# Access Compliance Report

## Public Rights-of-Way

### (Curb Ramps)

Intersection ID: 17285	Main Street: SHARON_RD	Cross Street: WESTMINSTER_PL	Location: SE
ADA ID: 406646230DF9	Ramp Type: BlendTrans1	Initial Pass/Fail: Fail	Overall Compliance: No
Severity Score: 1.25			
Codes/Mitigation Info/Possible Solution		Field Measurements/Component Compliance

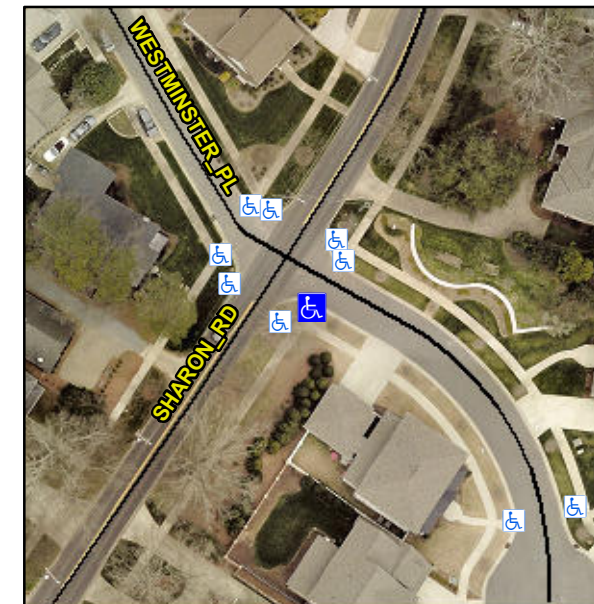
Compliance	Description	Data	Compliance	Description	Data
N/A	Ramp Length (in)	83.0	Yes	BlendTrans Slope (%)	2.3
Yes	Ramp Width (in)	48.0	No	BlendTrans XSlope (%)	3.7
N/A	Flare Type LT	N/A	N/A	Flare Type RT	N/A
N/A	Flare Slope LT (%)	N/A	N/A	Flare Slope RT (%)	N/A
N/A	Flare Traversable LT?	N/A	N/A	Flare Traversable RT?	N/A
N/A	Landing Length (in)	N/A	N/A	DWS Provided?	N/A
N/A	Landing Width (in)	N/A	N/A	DWS Contrast?	N/A
N/A	Landing Slope (%)	N/A	N/A	DWS Length (in)	N/A
N/A	Landing X Slope (%)	N/A	N/A	DWS Full Width?	N/A
N/A	Landing Curb? (Y/N)	N/A	N/A	DWS Offset (in)	N/A
N/A	Shared Landing?	N/A			
N/A	Gutter Ponding?	N/A	N/A	Gutter Slope (%)	N/A
N/A	Gutter Lip Ht (in)	N/A	N/A	Gutter X Slope (%)	N/A
N/A	Painted X Walk1?	No	N/A	Painted X Walk2?	N/A
	X Walk 1 Direction	To NE		X Walk 2 Direction	N/A
	X Walk 1 Width (in)	N/A		X Walk 2 Width (in)	N/A
	X Walk 1 Slope (%)	1.1		X Walk 2 Slope (%)	N/A
	X Walk 1 X Slope (%)	4.3		X Walk 2 X Slope (%)	N/A

**Remove & Replace Curb Ramp With Two New Directional Ramps or Equivalent.**

**R304.5.3**
